Staff Report

Land Division (Tentative Subdivision Plat)

SD-07-19

A NEW 6 LOT SUBDIVISION
3171 GRAND PRAIRIE RD., SE
ALBANY, OR
TITLE SHEET

A **CONVERSION PLAN**
SCALE: 1" = 30'

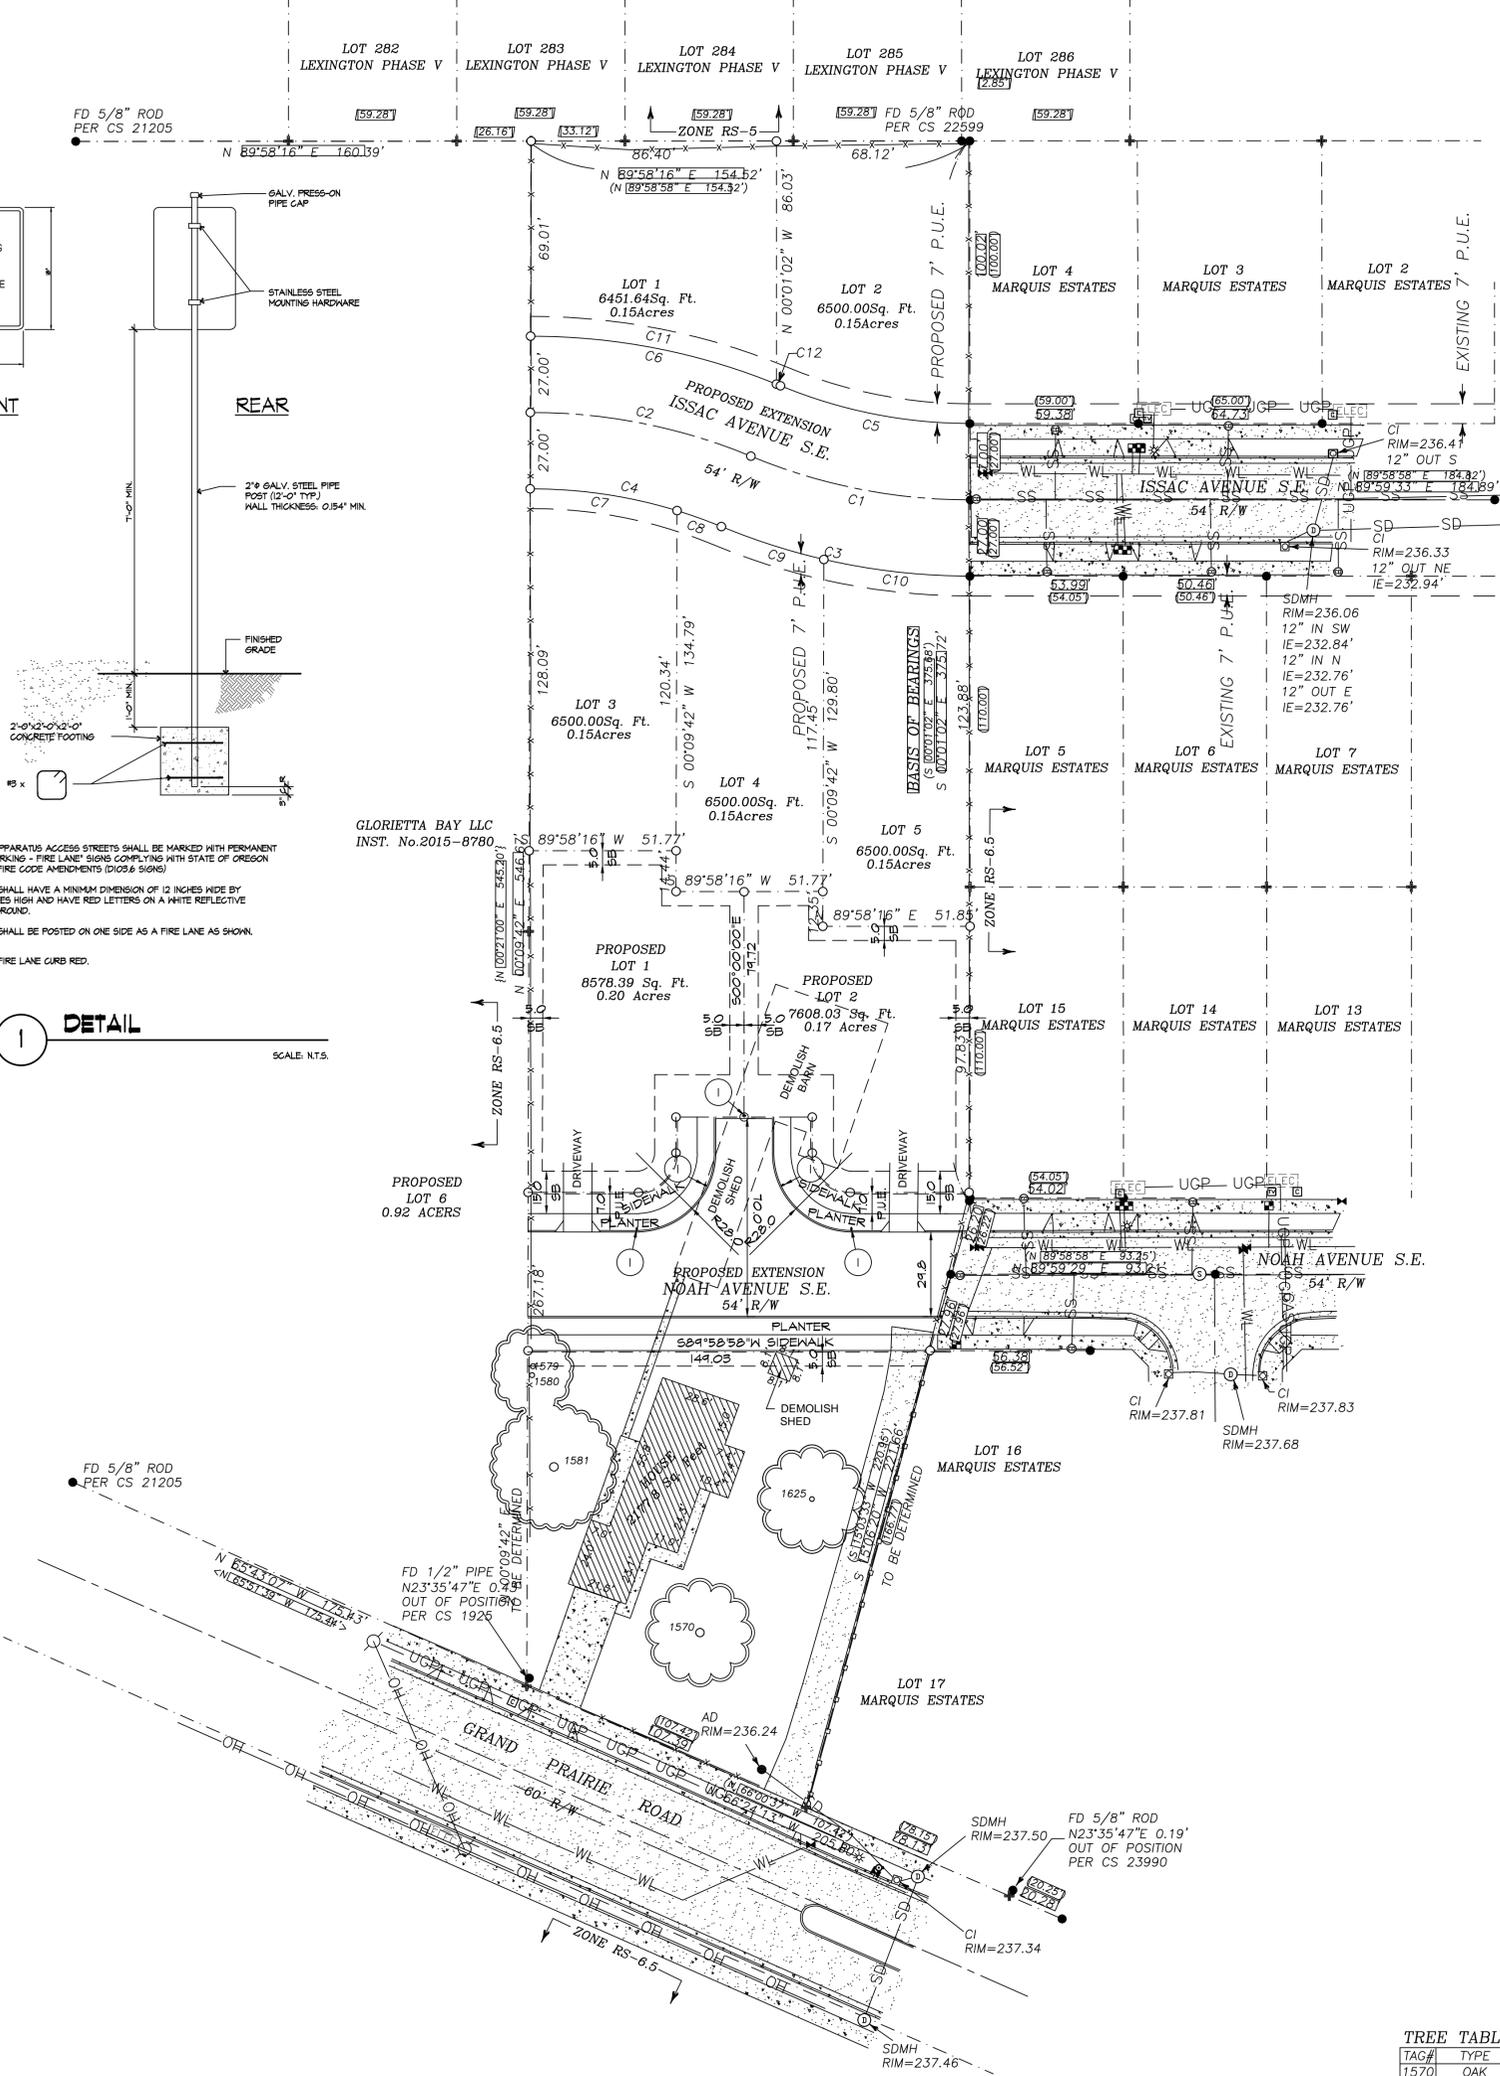
- 2.1 The subject property is approximately 1.91 acres in size. Lots 1-6 range in size from 6,500 to 40,075 square feet with an average minimum lot size of roughly 12,276 square feet. The proposed subdivision would leave a portion of the subject property with an existing single-family residence and accessory structure as a remaining .92-acre lot with further potential for development.
- 2.2 In accordance with ADC 11.090(2) the applicant has submitted an urban conversion plan that adequately depicts how the remaining property can be developed in accordance with the zoning designation and other standards of the development code.

- 2.1 The applicant has submitted a satisfactory urban conversion plan.
- 2.2 This criterion is satisfied without conditions.
